Re: Cargill Fertilizer, Inc.
Riverview Nos. 3 and 4 Phosphoric Acid Plants
PSD-FL-231 (0570008-004-AC)

RE: PSD-FL-231/0570008-004-AC

RE: PSD-FL-231 (0570008-004-AC)/Production Rate Increase for
Phosphoric Acid Plants 3 & 4 from 139 to 170 TPH P205

#3 FILTER SCRUBBER

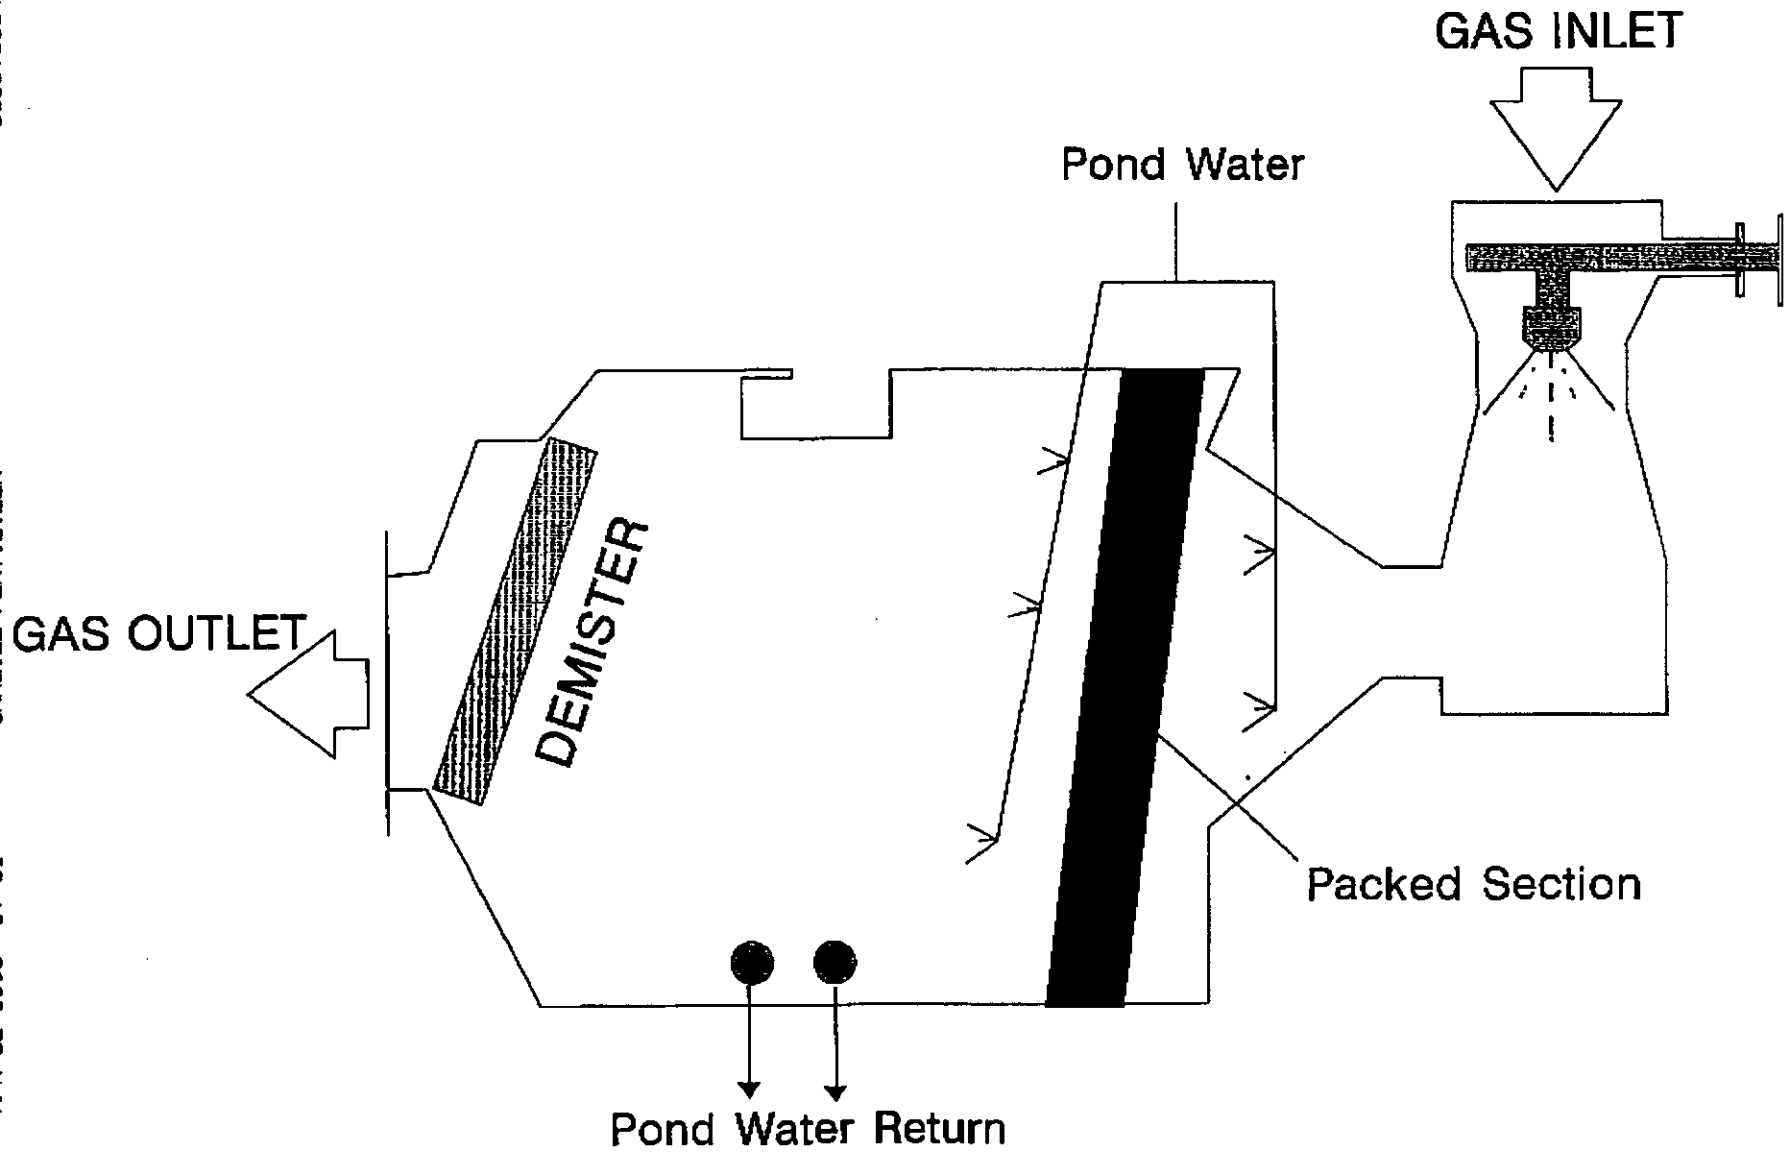
The news that Cargill plans to modify the existing scrubber to meet BACT requirements is well received. However, the Department must have an indication of exactly what the modification will entail and the design efficiency of the scrubber after the packing modification. This can be done by providing a sketch of the modified system and the scrubber vendor's performance guarantee or design calculations showing the fluoride removal efficiency.

The Department received Cargill's response to our October 12 preliminary incompleteness letter on November 14 (PSD-FL-231). We cannot agree with Cargill's contention that the existing venturi scrubber installed for the No. 3 filter under a previous non-PSD permit should qualify alone as BACT technology without adding a packed secondary scrubber. This is not consistent with the BACT determination for the Bartow project, which states that either a packed scrubber or a venturi followed by a packed scrubber is required to meet BACT requirements.

1. Cargill is considering installing packing by Kimre, Inc., on the existing scrubber. A sketch of the modified scrubber is attached. In this arrangement, there will be one stage of packing, with six layers of packing per stage. Kimre states that one stage of packing results in 3 NTUs (number of transfer units).

As a result of adding the packing, the modified No. 3 filter scrubber will now consist of a venturi section followed by a packed bed section. The scrubber will then resemble closely the existing scrubber on the Dorrco (No. 4) phosphoric acid reactor. The primary difference between the two scrubbers will be the distance between the packed bed section and the demister section: in the No. 3 Filter scrubber, the length of this section will shorter than in the No. 4 Reactor scrubber.

This analysis demonstrates that a packed bed section installed on the No. 3 Filter scrubber will have virtually no effect on fluoride emissions and is unnecessary (existing venturi scrubber provides at least 3 NTUs itself). However, Cargill will proceed with installing the packing in this scrubber, as described above and shown in the attached drawing, if the Department requires it.

Figure 1. Plot of Fluoride Removal Efficiency vs. NTUs
for a Wet Scrubbing System with Various Inlet Loadings

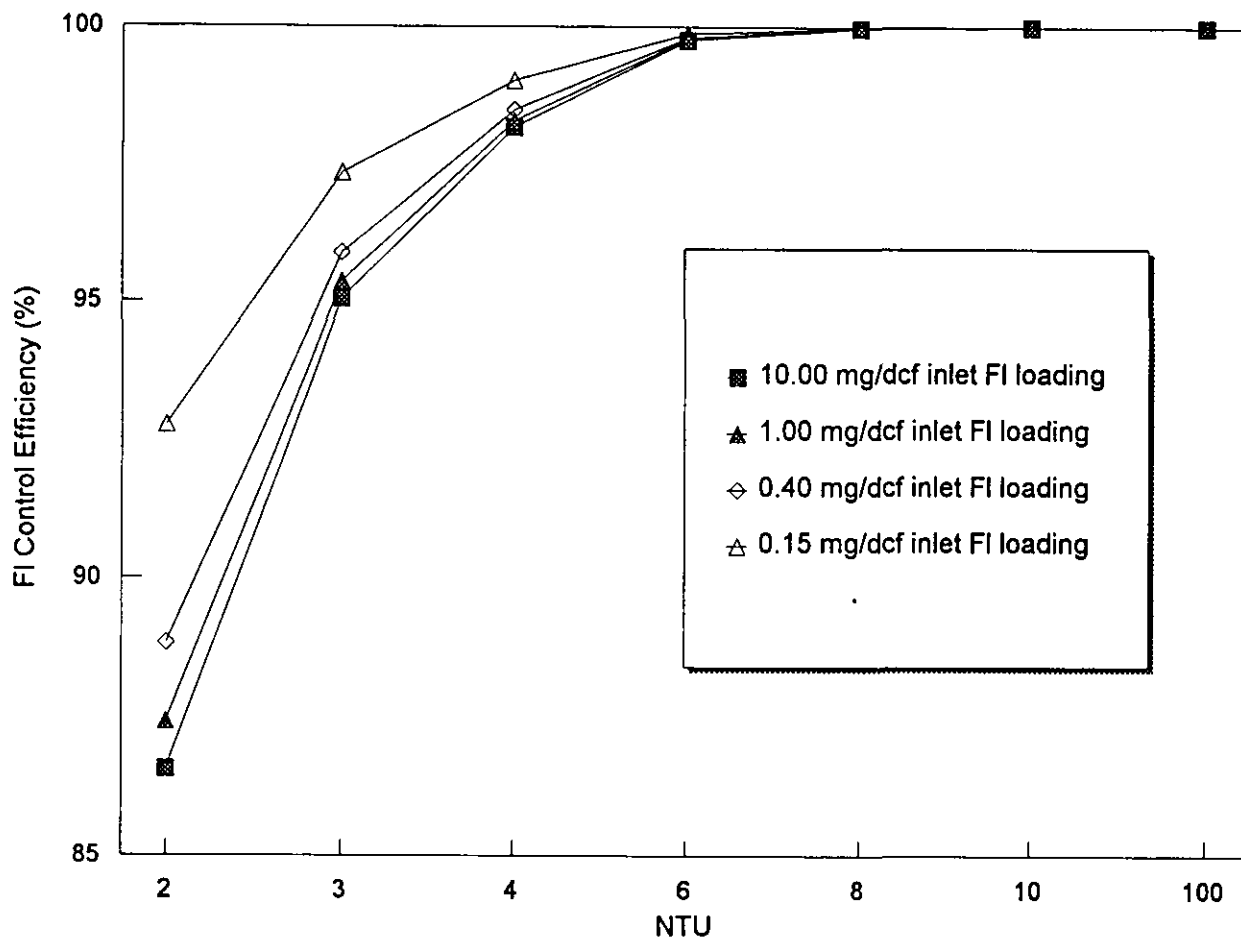
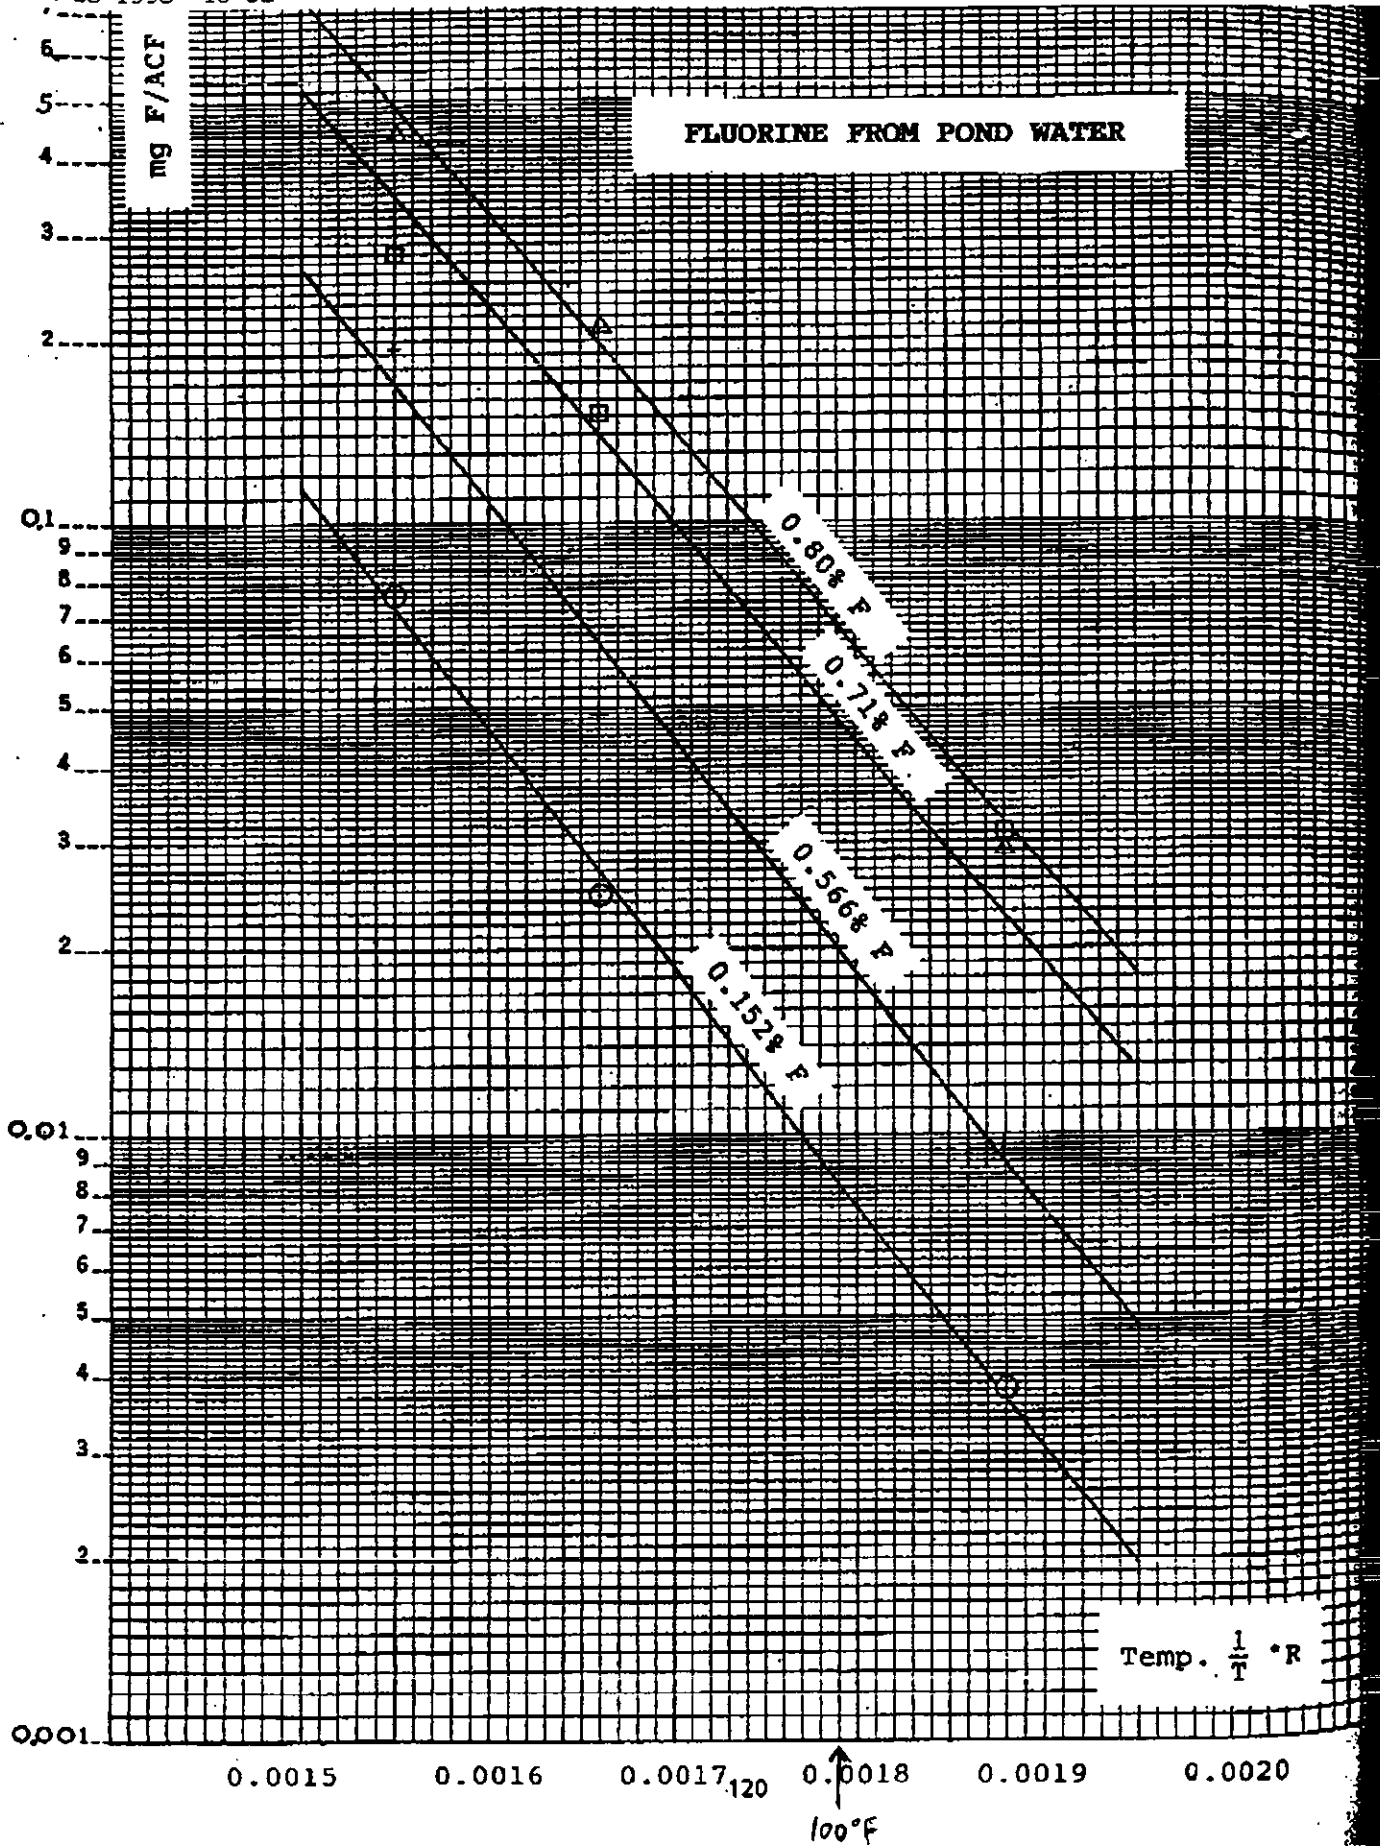
The May 31 letter was the result of KBN's calculations not having been done in a conventional manner to represent the percent of actual removal for 8,000 ppm F pond water. The figures had been adjusted by removing the equilibrium concentration from the outlet stream. This made the efficiency appear higher (per cent of 'possible' vs. 'actual'). The calculation of 99.8% removal is actually 82.3% and NTU = 5.79 for the conditions selected (100°F and 8,000 ppm). The 82.3% compares to actual removal efficiencies of 99+% for other BACT installations where as many as 8 NTU's have been achieved with unneutralized pond water.

The Department did not agree with the April 15 letter stating that it is unnecessary to go beyond 4 NTUs because the literature and data show otherwise. There are numerous installations in the phosphate industry that have more NTUs. Dr. A. J. Teller's March 1967 article regarding fluoride removal states:

The Department did not agree with the argument that a 'point of diminishing returns' lies at 4 NTUs. BACT determinations must be

Another problem is the claim that the venturi will achieve at least 3 NTUs itself. At a pressure drop of 0.45 inches H₂O, data available to the Department indicate that the existing venturi would probably not exceed 2.0 NTUs.

KBN has developed a spread sheet and graph based on this equation which shows the relationship between scrubber inlet fluoride concentration, scrubbing water fluoride concentration, NTUs, and fluoride removal efficiency. These are attached as Table 1 and Figure 1.

Several important observations can be made from these data. First, scrubber fluoride removal is limited by the pond water fluoride concentration. Theoretically, an outlet fluoride concentration lower than the vapor pressure exerted by the pond water cannot be achieved. In the data shown in Table 1, a pond water fluoride concentration of 8,000 ppm is assumed (based on Riverview pond water). At 100 deg. F temperature, the equilibrium fluoride concentration in air is 0.070 mg/dcf. Thus, the outlet fluoride concentration can never be less than 0.070 mg/dcf. Therefore, to adequately represent the true Fl removal capability of the system, an "adjusted removal efficiency" is presented in Table 1. This efficiency was calculated considering that the minimum achievable outlet concentration is 0.070 mg/dcf, as follows:

The limitation on fluoride outlet concentration limits the fluoride removal efficiency achievable by the scrubber, regardless of the number of NTUs. This is shown in the table and graph, which clearly shows that the outlet fluoride loading asymptotically approaches 0.070 mg/dcf as the number of NTUs increases. Thus, there is no benefit in increasing the number of NTUs in the scrubbing system beyond a certain point (i.e., where little or no reduction in fluoride emissions occurs).
